## REVISED RESPONSE TO REQUEST FOR ADDITIONAL INFORMATION

### APR1400 Design Certification

Docket No. 52-046

RAI No.: 244-8326  
SRP Section: 09.03.03 – Equipment and Floor Drainage Systems  
Application Section: 9.3.3  
Date of RAI Issue: 10/14/2015

Figure 1. Turbine Generator Building Drain System

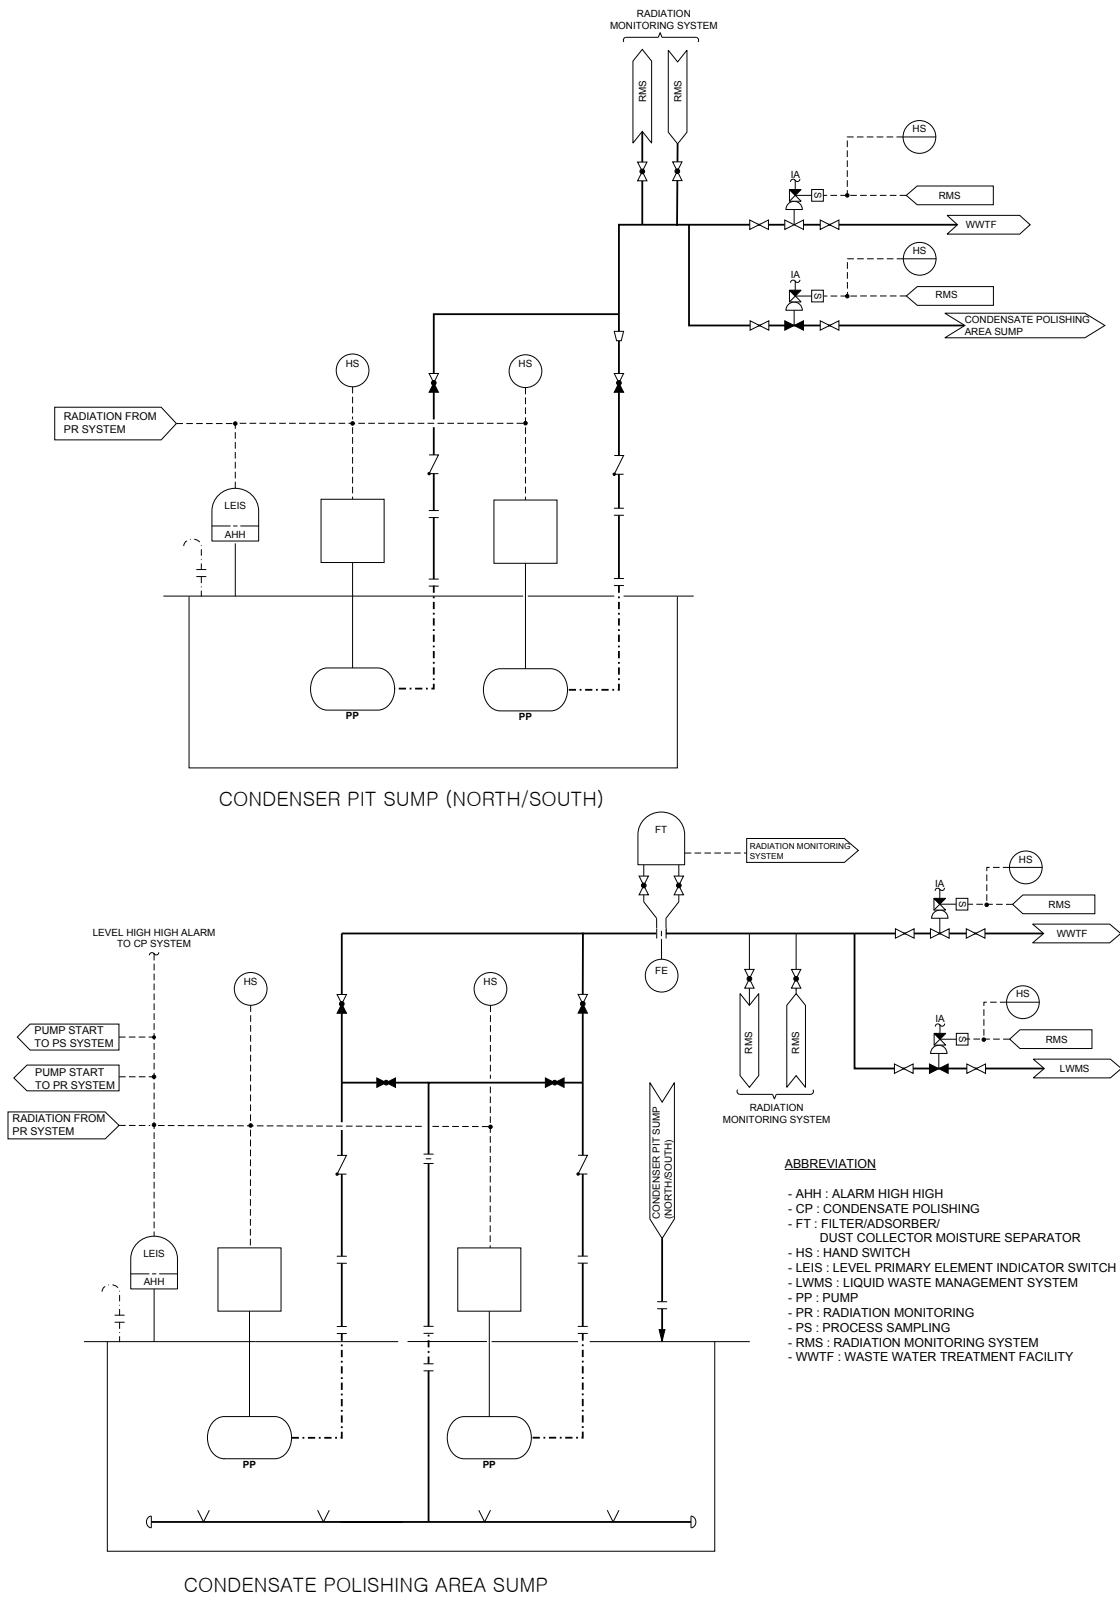
DCD Tier 2, Figure 9.3.3, “Equipment and Floor Drainage System,” depicts the EFDS including the radioactive subsystem in the auxiliary building. However, this figure only shows certain portions of the EFDS, specifically the radioactive portions in the auxiliary and compound buildings. This figure is missing information depicting the reactor containment building subsystems, the turbine generator building subsystems, and the identification of the safety-related and nonsafety-related portions of the EFDS. In addition, the figure does not show the interconnection of the turbine generating building sump pump discharge between the liquid waste management system (LWMS) and the waste water treatment facility (WWTF).

The applicant is requested to provide the above information in DCD Tier 2, Table 3.2-1, Figure 9.3.3, and Section 9.3.3, in order for the staff to adequately review the EFDS design against GDC 60.

The turbine generator building drain system consists of the condenser pit sumps (north/south) and a condensate polishing area sump. The figure 1 shows the interconnection of the turbine generator building sump pumps between the LWMS and the WWTF.

All sump pumps discharge into the WWTF when radioactivity of fluid is below a predetermined setpoint. The discharge from the condensate polishing area sump is monitored for process radiation. When contamination level is detected at or exceeding a predetermined setpoint, the operating sump pump is stopped automatically by the RMS signal. The discharge valve to the WWTF is closed and the discharge valve to the LWMS is opened. Then, the sump pump is manually started. The flow is then diverted to the LWMS.

The discharges from the condenser pit sumps are monitored for process radiation. When contamination level is detected at or exceeding a predetermined setpoint, the operating sump pumps are stopped automatically by the RMS signal. The discharge valve to the WWTF is closed and the discharge valve to the condensate polishing area sump is opened. Then, the sump pump is manually started. The flow is then diverted to the condensate polishing area sump and finally to the LWMS.

The DCD will be revised to state that the COL applicant is to provide the classification of structures, systems, and components and the flow diagram for turbine generator building drain system.
